From: Anita Gardner
Sent: 13 September 2017 16:08
To: Planning.Responses
Subject: FW: FG/108/17/DOC - Condition 4 Internal Noise levels - Ferring

From: David Linton-Clowes - TW Southern Counties [REDACTED]
Sent: 13 September 2017 15:25
To: Anita Gardner
Subject: RE: FG/108/17/DOC - Condition 4 Internal Noise levels - Ferring

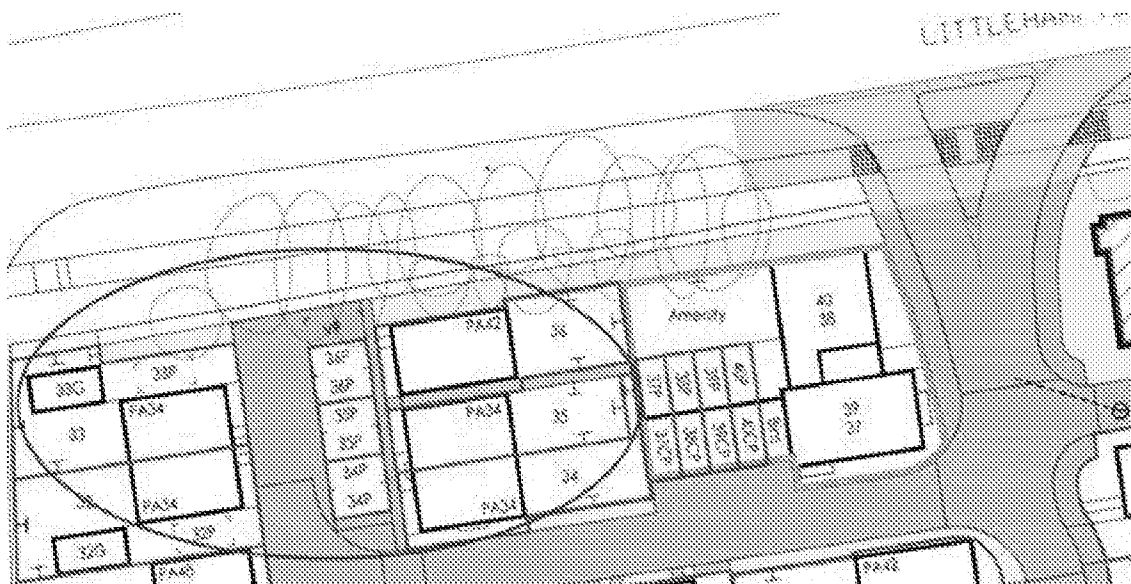
My question was regarding the remaining units which as you will see in the below image have only plot 36 adjacent to the a259 with 35 and 34 protected by 36.

We intend on carrying out the testing in 2 weeks time so to avoid any disruption I wanted to check if this was an error and instead the condition should state 33 and 36 or if you would like me to carry out testing to the 3 units listed in the condition?

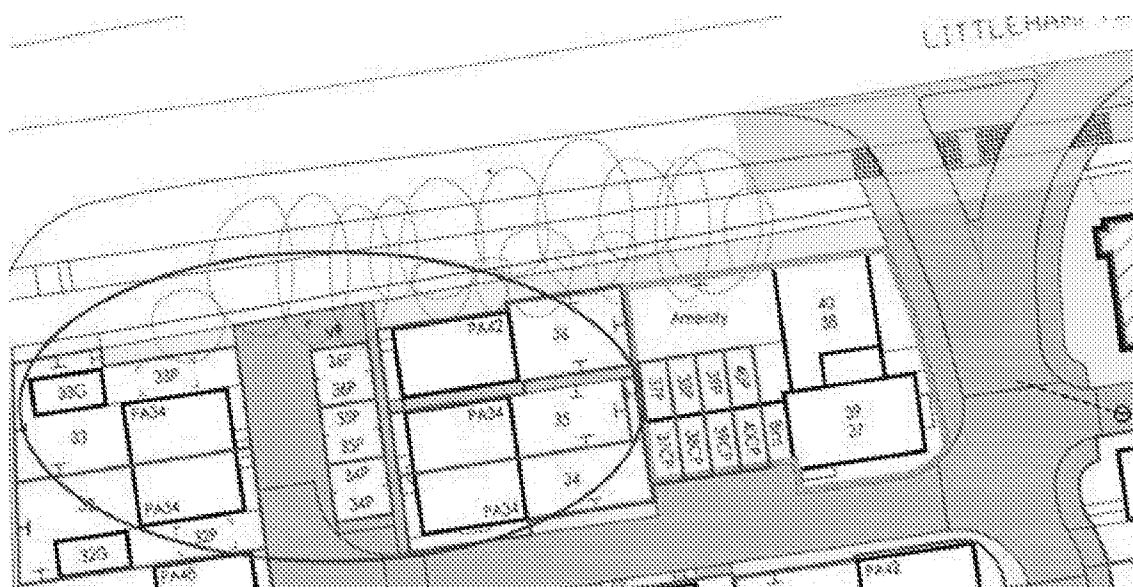
Going forward we still are due to test more plots alongside the A259. The condition does ask for testing of 3 plots (34-36) however only one of those plots front on to the A259 and we intend on testing the two left on site that do (33 and 36). Please see the exert of the site below for reference.

Can you please confirm that you would like Taylor Wimpey to test plots 33 and 36 instead of what is stated in the condition as 34-36 that contains two units that are shielded by plot 36 or if you would like us to test all 3 units as stated?
